Target Denim & Casual Wear Ltd.

27th January and 4th February 2019

Observations

8mm flange thickness of rafter

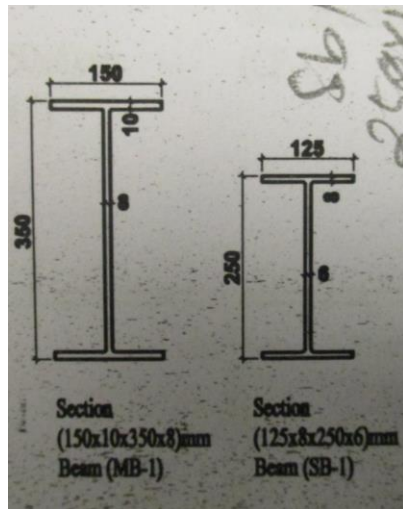
Flange thickness rafter was found 6mm instead of 8mm

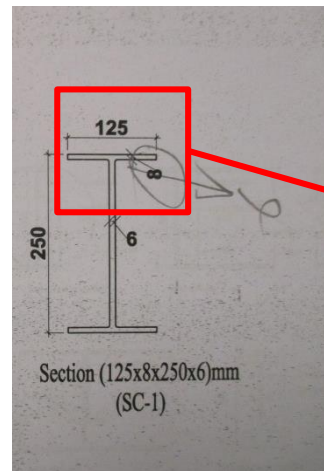
Flange thickness of mezzanine floor main beam and sub-beam was found 6mm instead of 100mm and 8mm respectively.

Flange thickness of mezzanine floor column was found 6mm instead of 8mm

DESIGN & DEVELOPMENT SOLUTION

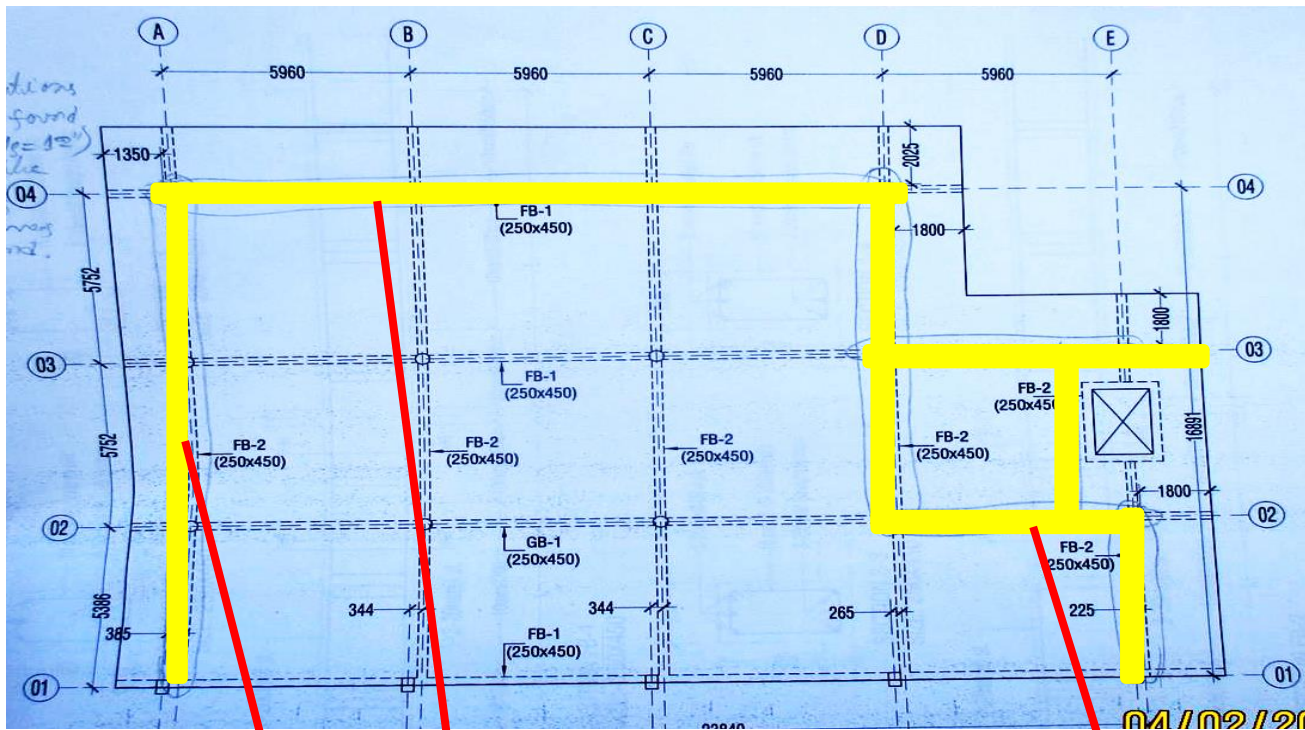
As per the recommendation of DEA report, existing structure is non-engineered. A set of drawings was produced for the new structures instead of existing structure. The factory is required to demolish the existing structure or implement the recommendations of prepared DEA report.

ITEM-6: DEA recommendation to be implemented.

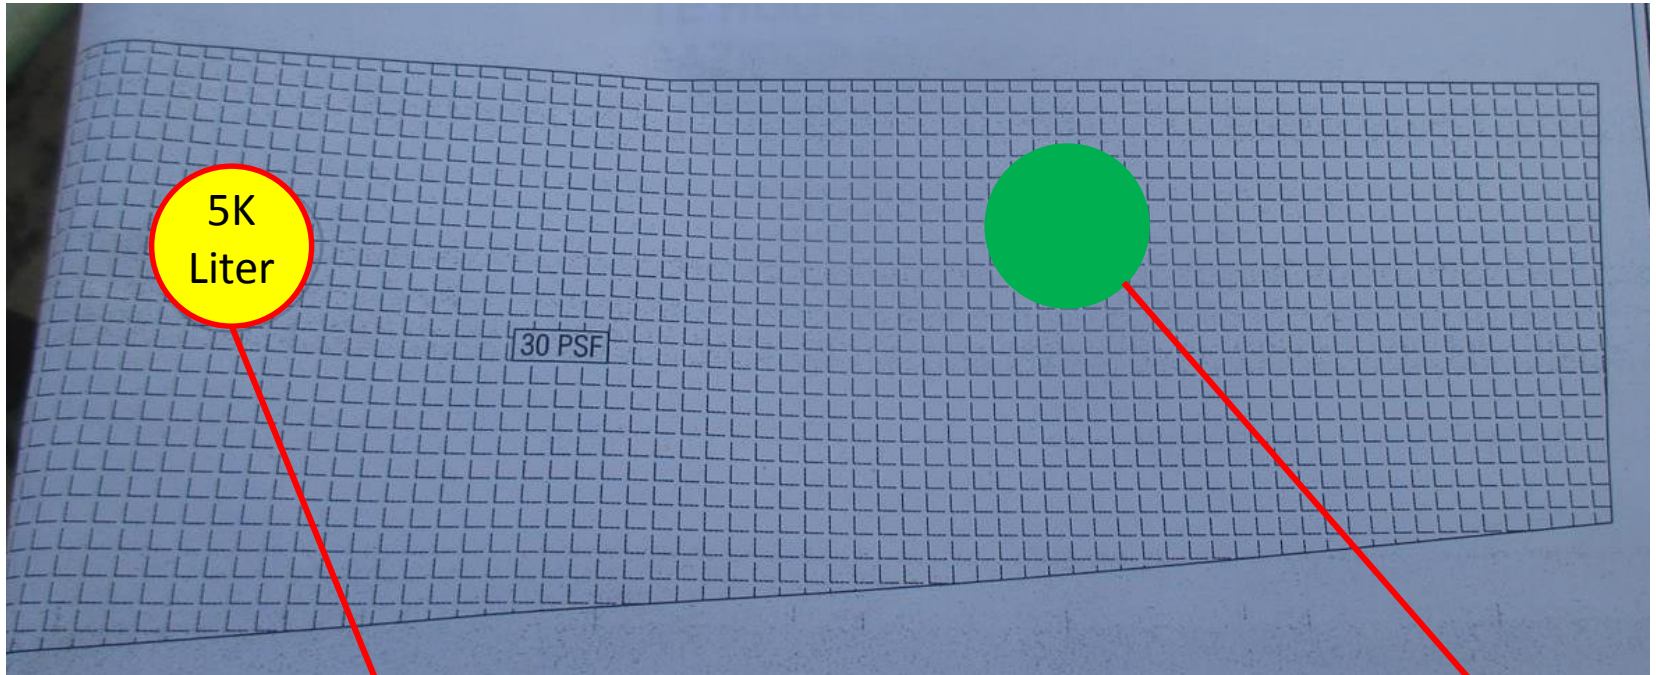
Column at grid A/2 & A/1 has been shown circular in column schedule. During inspection, this two column was found rectangle with size of 300mmX300mm

**The roof floor beam was found partially casted
and the rebars were exposed to air**

Item No.	Observation	Recommended Action Plan	Recommended Timeline
15	Mismatch in as-built drawings. Building-2 (Security/Gatehouse Building)	Factory Engineer is required to survey the structure and develop as-built drawings to as-constructed status.	6-weeks
16	Mismatch in as-built drawings. Building-2 (Security/Gatehouse Building)	Factory Engineer to check the adequacy of rafter/beams based on as-built conditions.	6-weeks
17	Mismatch in as-built drawings. Building-2 (Security/Gatehouse Building)	Implement the recommendation of engineering assessment (if required).	6-months
18	The roof floor beam was found partially casted and the rebars were exposed to air. Building-2 (Security/Gatehouse Building)	Factory Engineer is required to cast the roof beam.	6-weeks

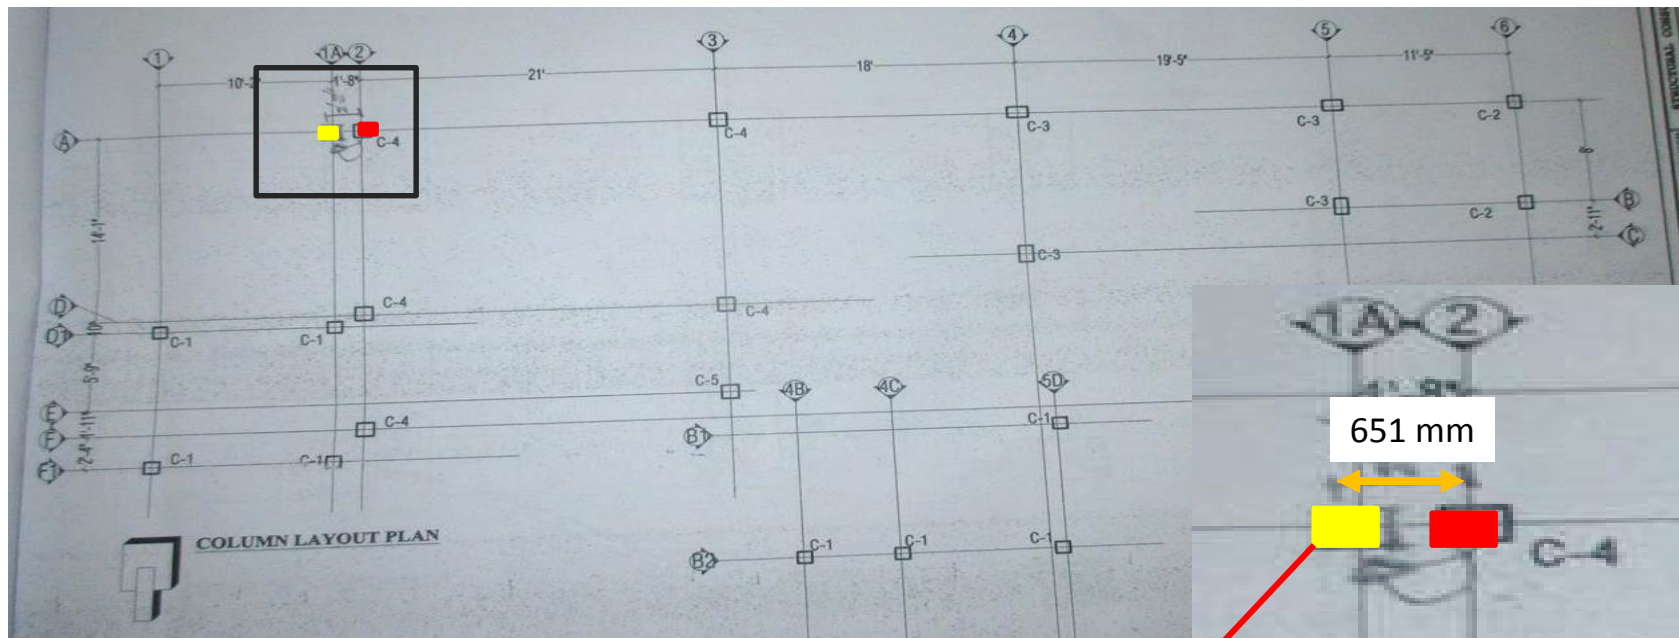
5K liter water tank was found at roof which has not been placed as per layout. Water tank was found at marked location.

Water tank was not found at this location

Signage of water ponding was found at roof level.

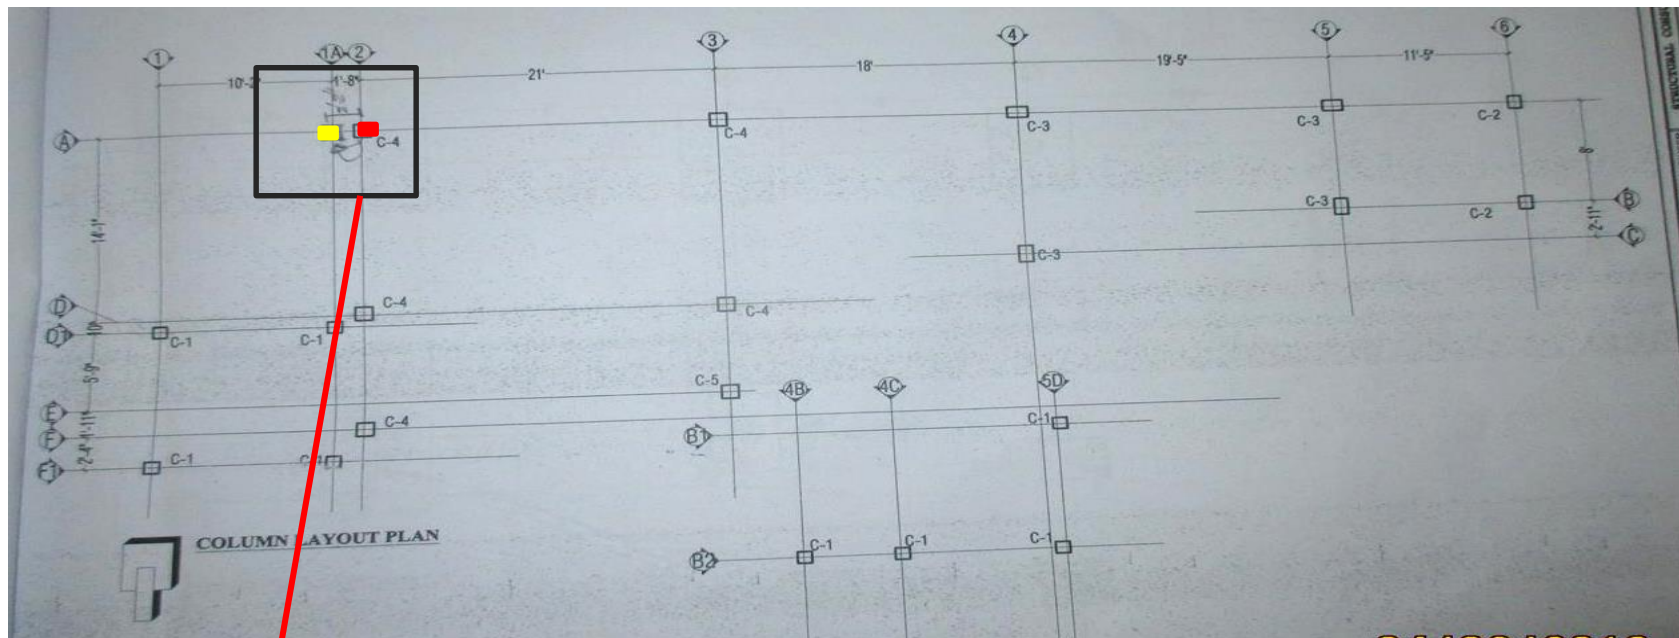
Column Layout plan does not match with actual site condition. Column was found at yellow marked location instead of red marked location

Steel column was found at ground floor at marked location. RCC column was found started above the steel column at 1st floor
